**E-54 Regional Lift Station - RFCSP
Solicitation Number: CO-00537
Job No.: 22-2502**

**ADDENDUM 2
October 25, 2022**

SAWS JOB NO. 22-2502
 JOB NO. 11500-51
 DATE SEPTEMBER 2022
 DESIGNER RM
 CHECKED JD DRAWN RO
 SHEET C4.07

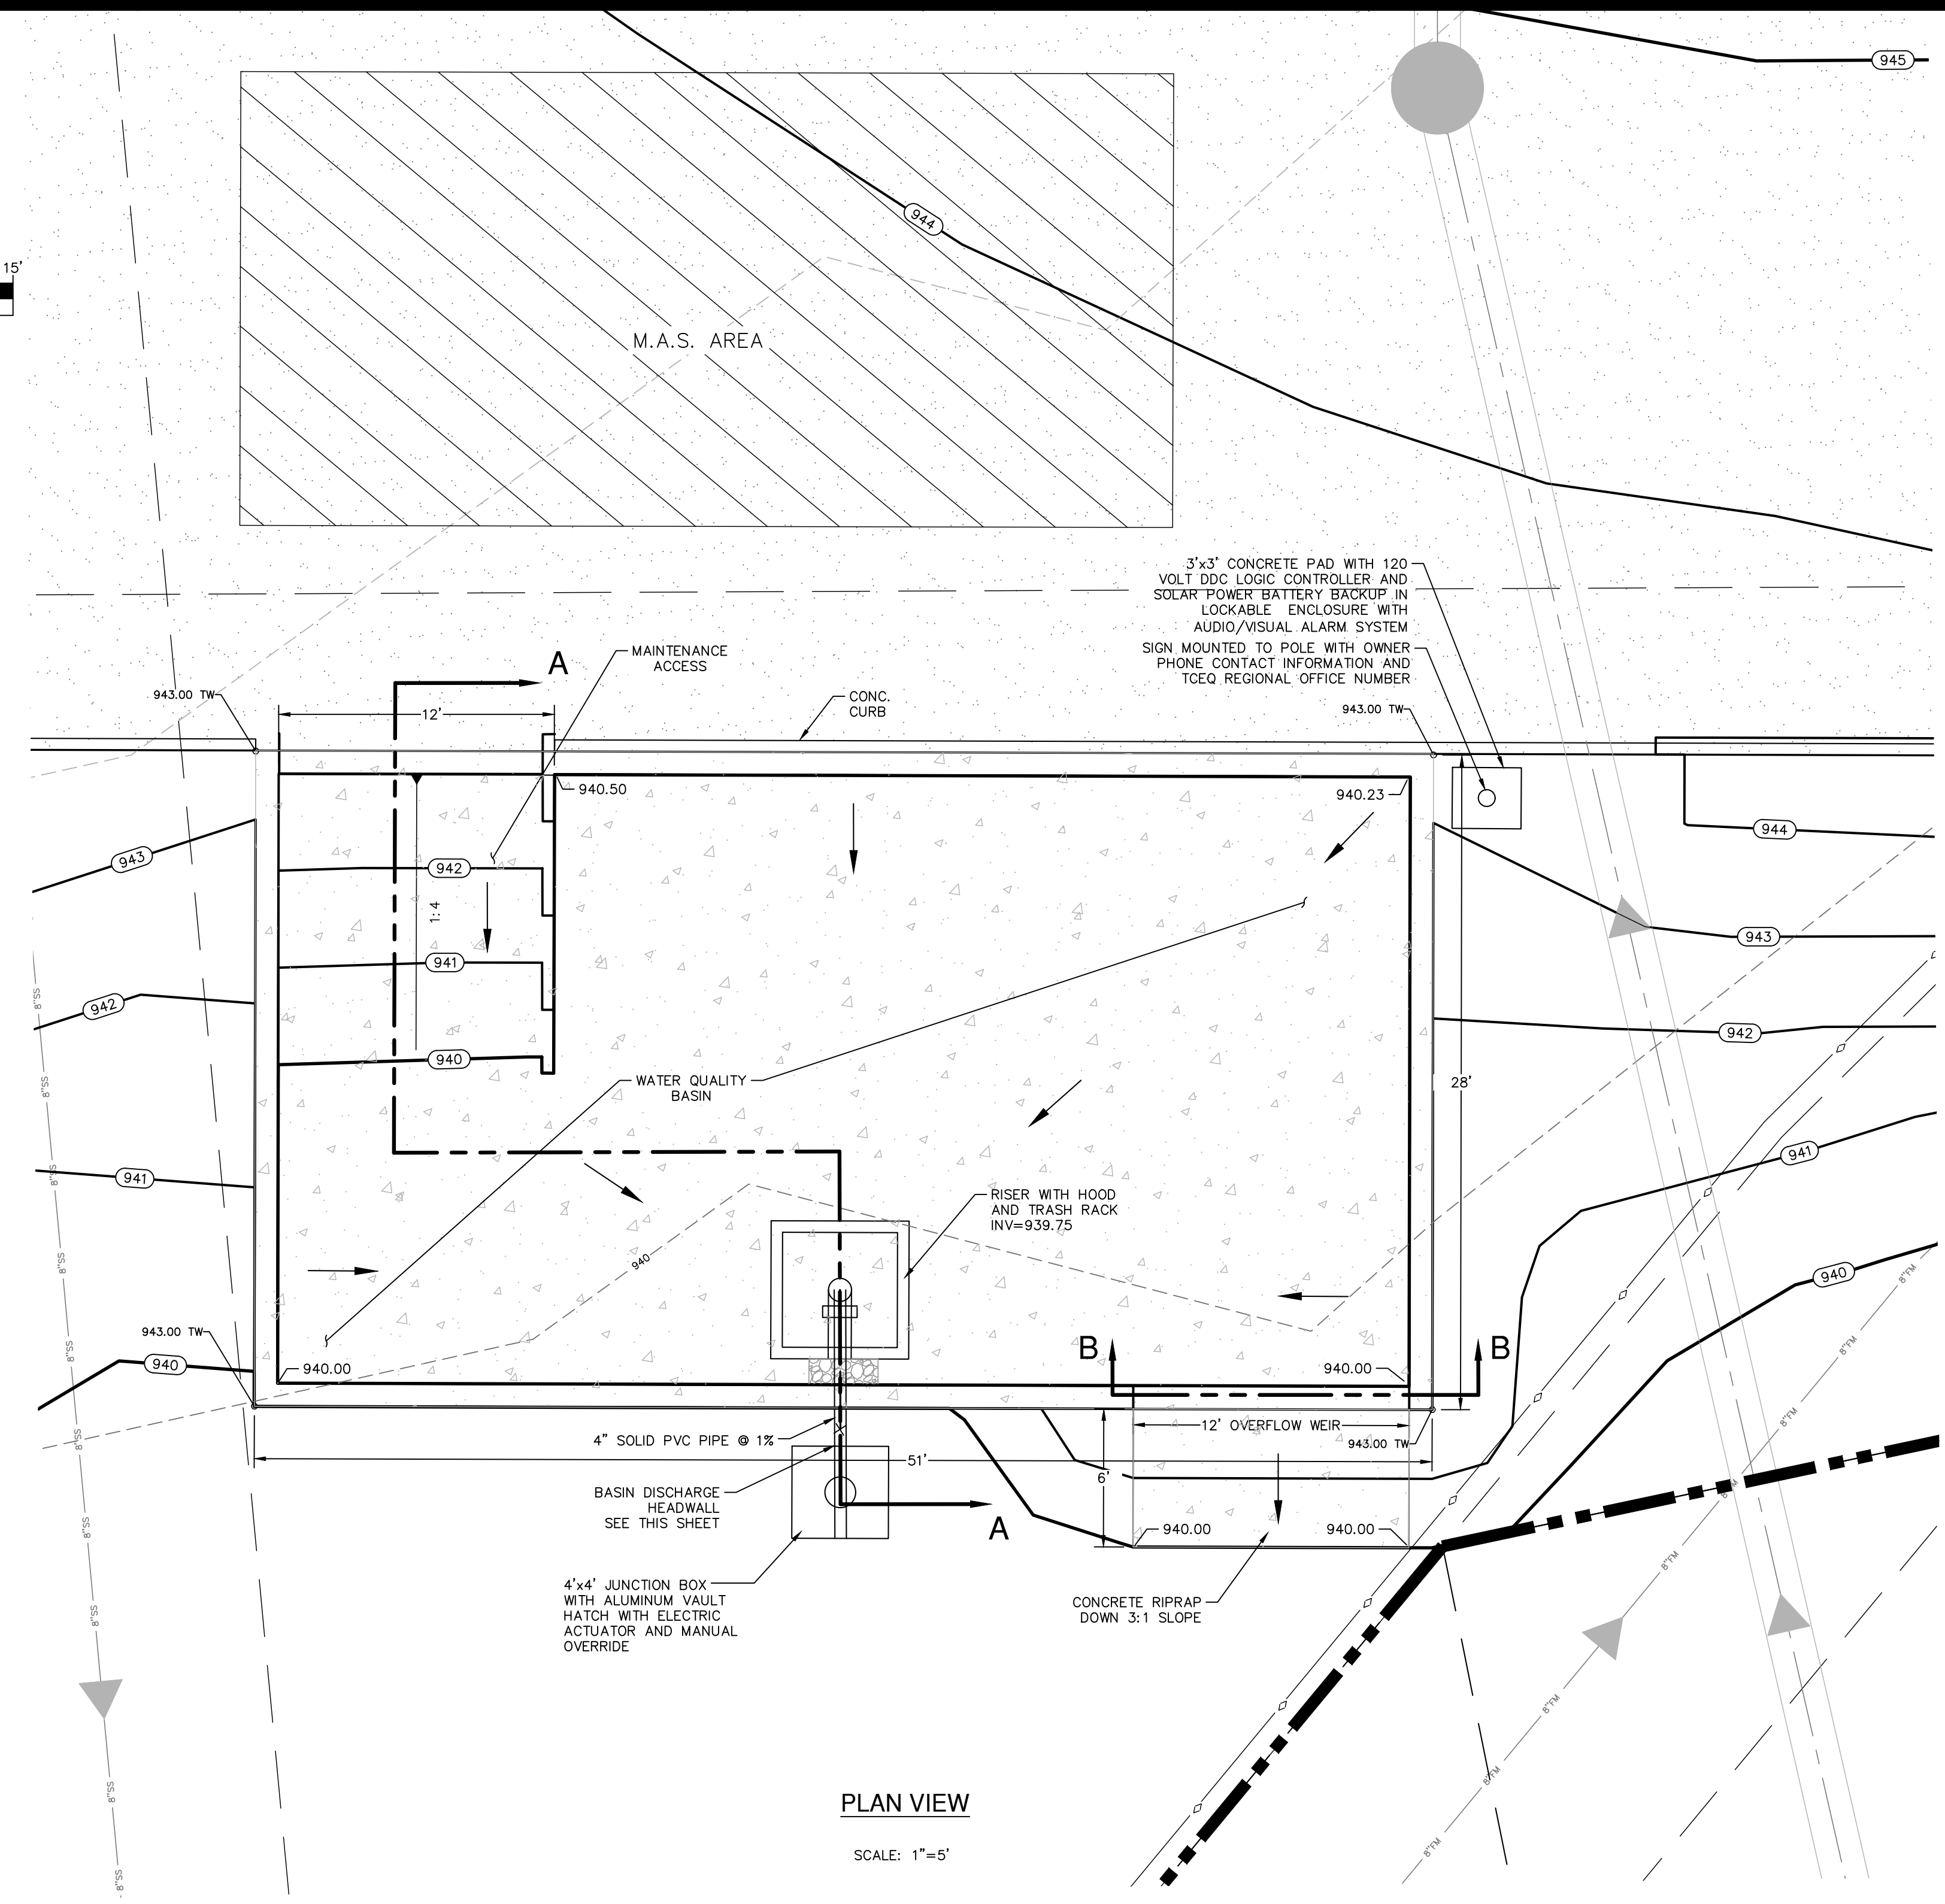
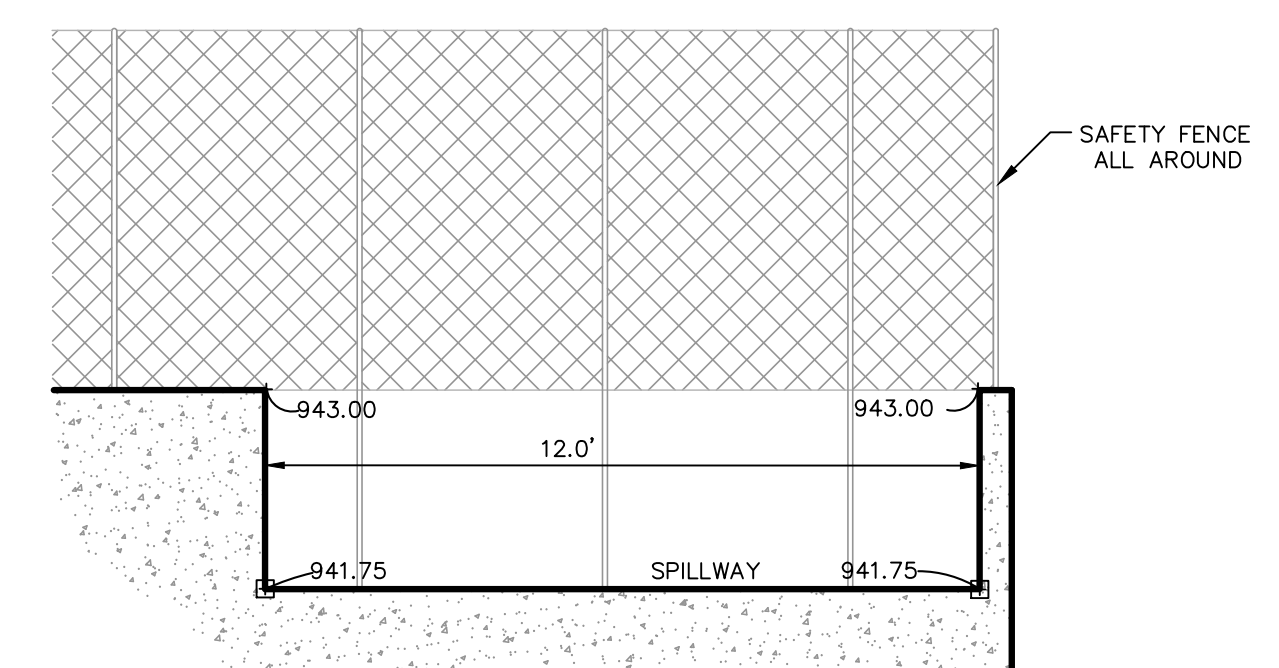
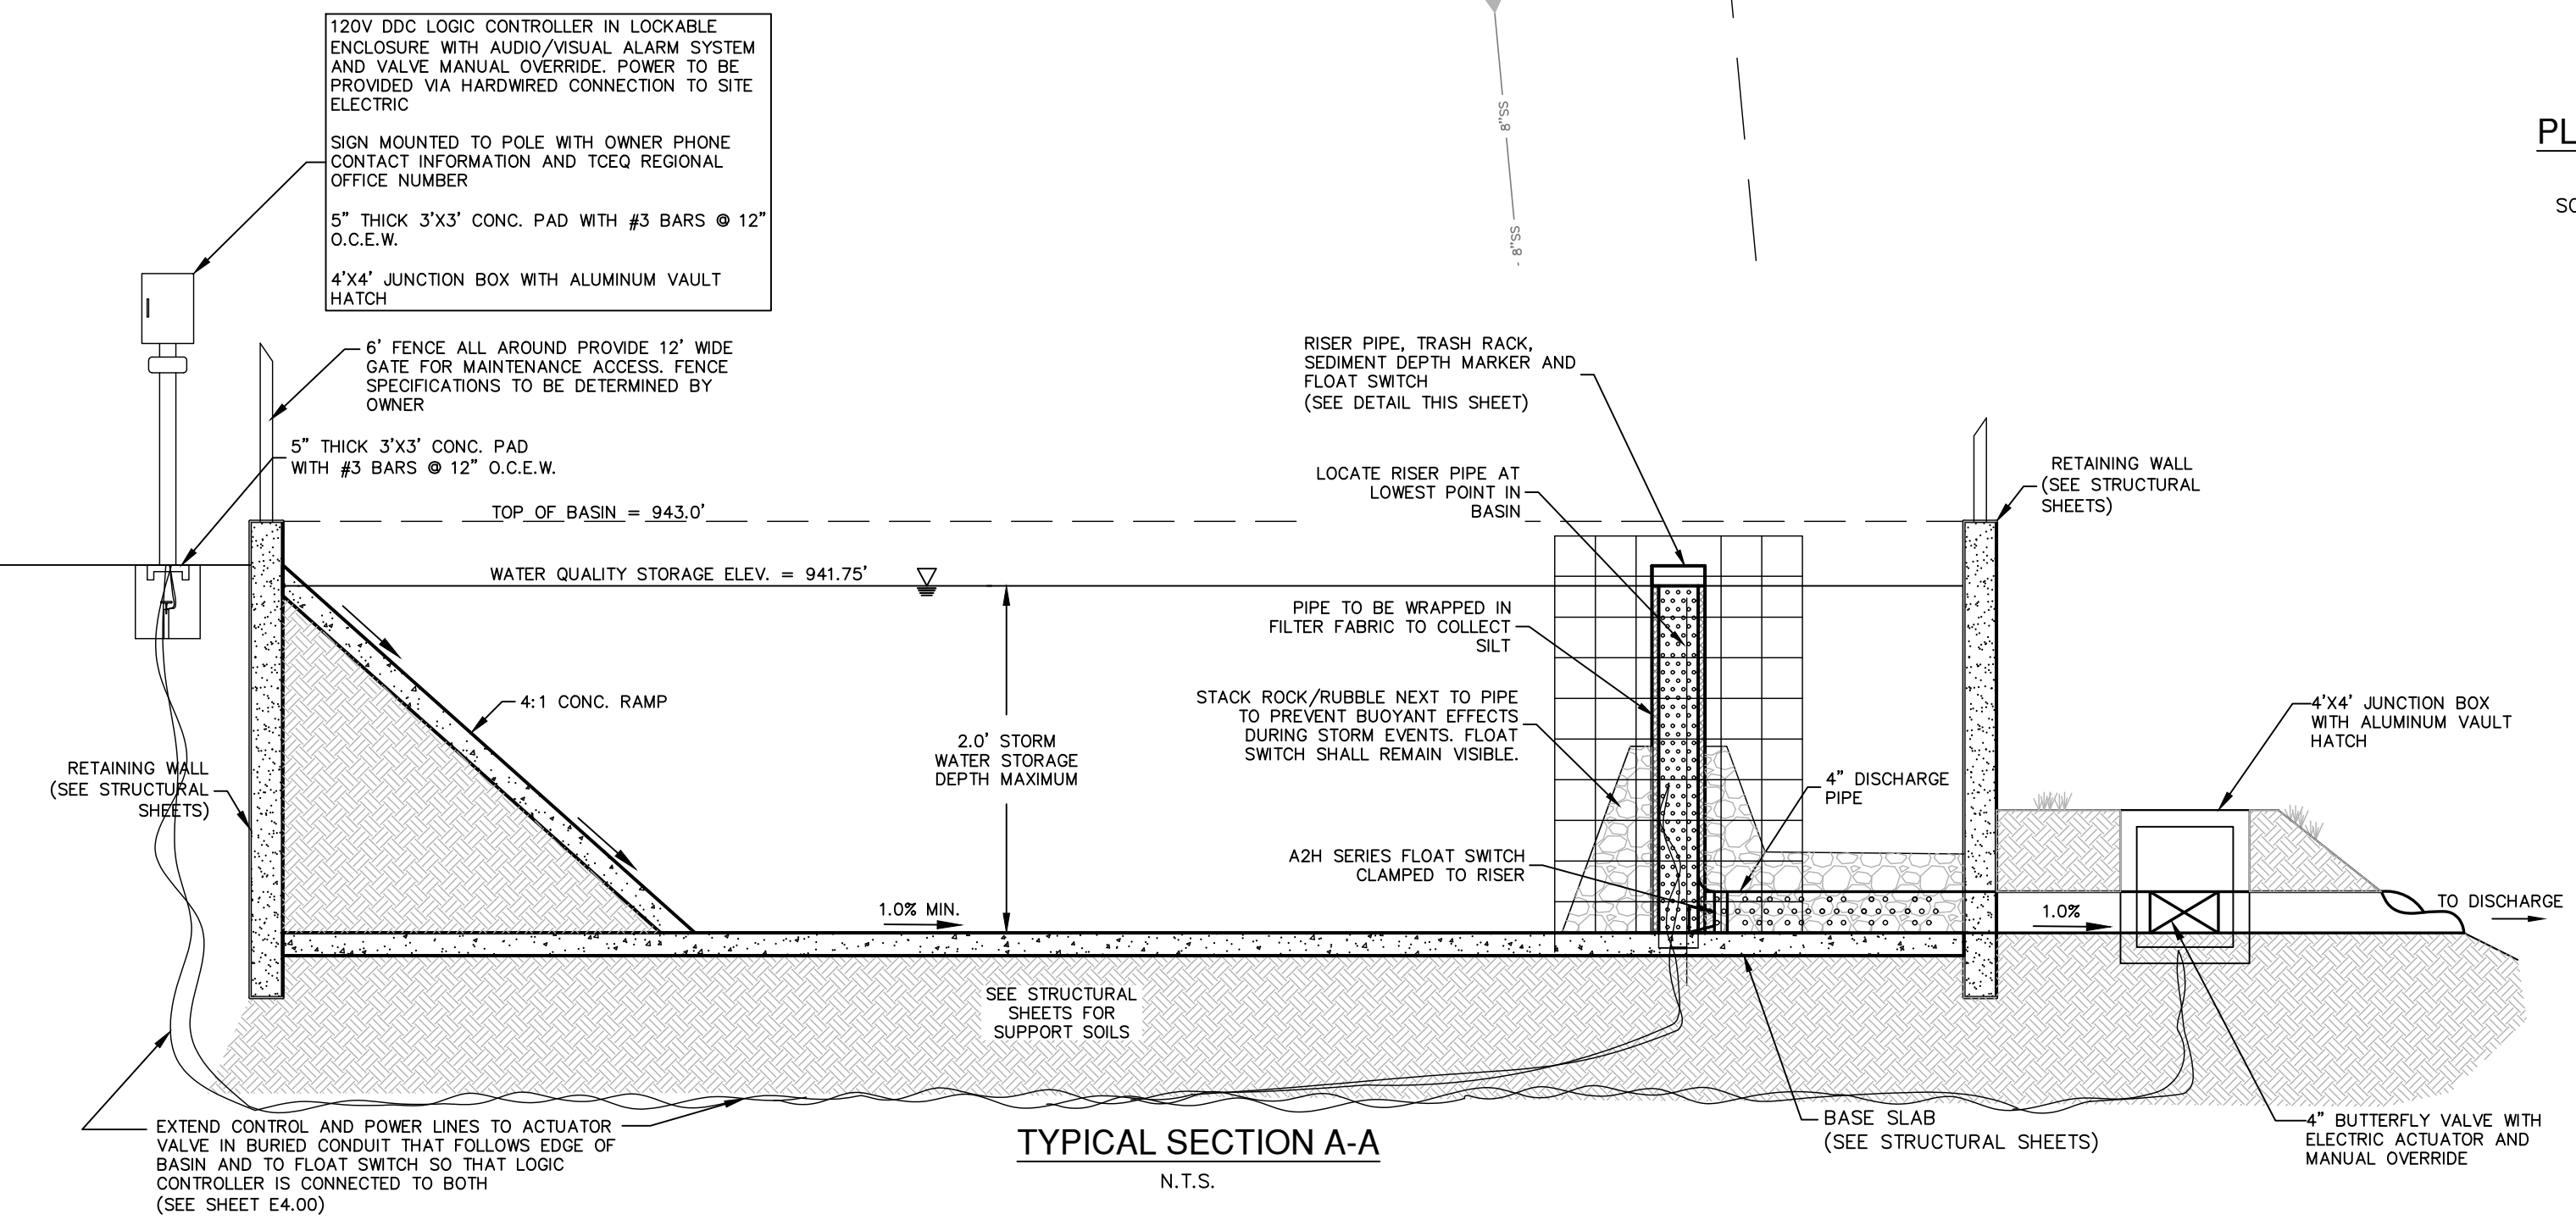
Ref Sheet C4.07. Can you provide a specification for the 4" Electric Motor Operated Butterfly Valve? Can you provide a detail of the 4'x4' Junction Box and the required size of the hatch?

RESPONSE: 4'x4' junction box shall be reinforced precast concrete (pedestrian rated). Hatch shall be 3'x3' hinged aluminum hatch (pedestrian rated) with spring assist. Four (4)-inch butterfly valve shall be Valworx Model No. 5670 or 5673. See revised Changes to the Plans #5.
